Proposal: Erection of 1 No. detached 2-storey, 5-bed dwelling with attached double garage (resubmission following A/176/17/PL). This application is a Departure from the Development Plan & affects a Public Right of Way.

Site: Land Between Badgers & Ashurst Ham, Manor Way, Angmering, BN16 4JQ.

A/87/18/PL

Southern Water MapGuide Browser

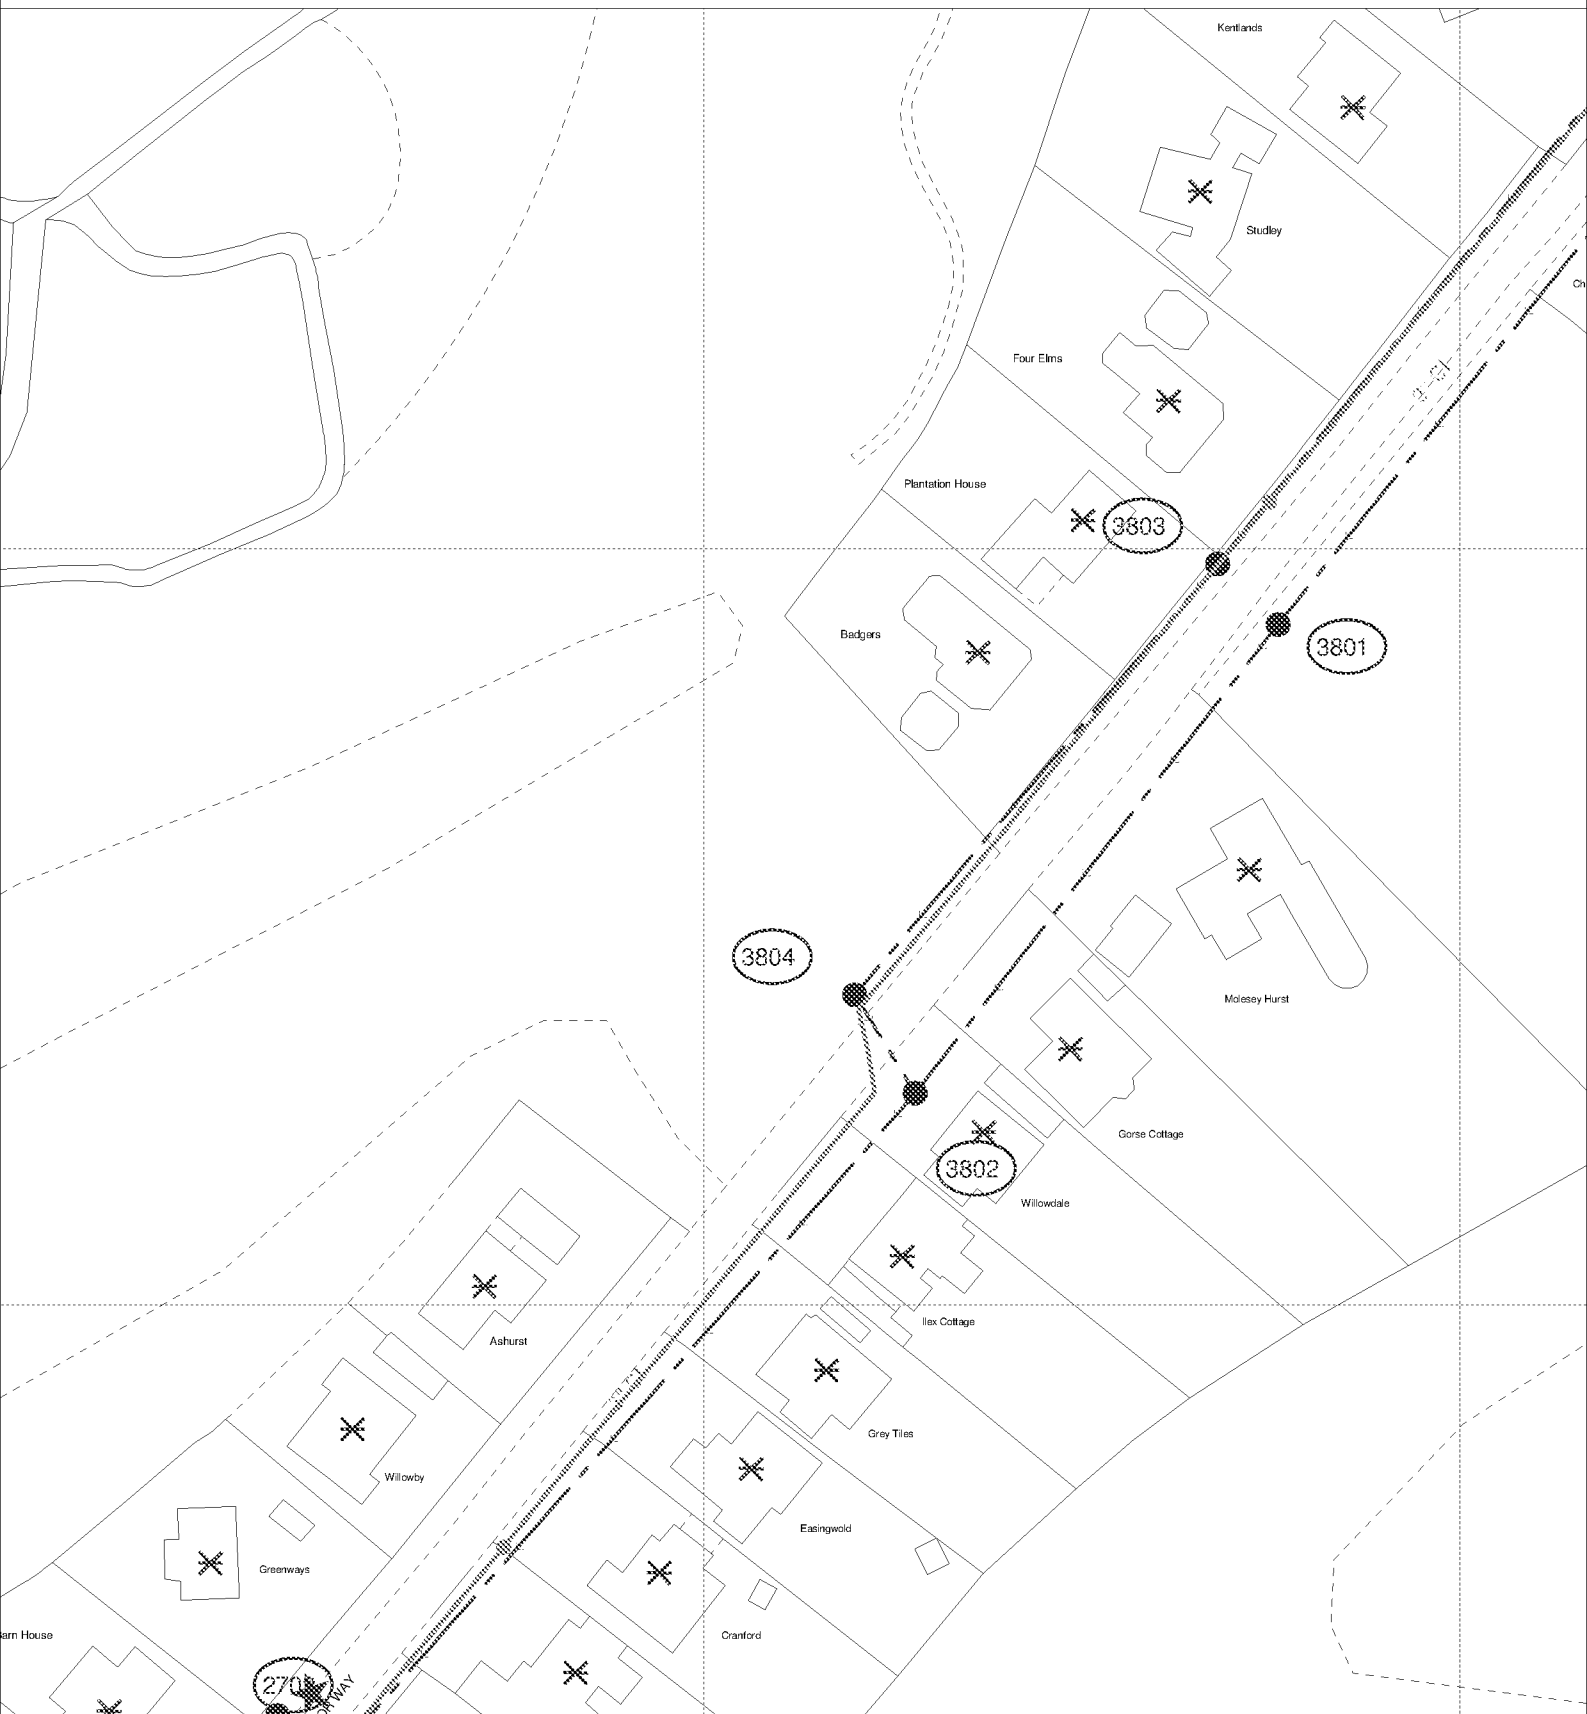
Please find attached a plan of the Southern Water records showing the approximate position of water mains and foul sewer within the site. The exact position of the water mains and foul sewer must be determined on site by the applicant before the layout of the proposed development is finalised.

- No development or new tree planting should be located within 6 metres either side of the centreline of the water mains
- No development or new tree planting should be located within 3 metres either side of the centreline of the foul sewer.
- No new soakaways should be located within 5m of a public sewer.
- All existing infrastructure should be protected during the course of construction works.

Our initial investigations indicate that there are no public surface water sewers in the area to serve this development. Alternative means of draining surface water from this development are required. This should not involve disposal to a public foul sewer.
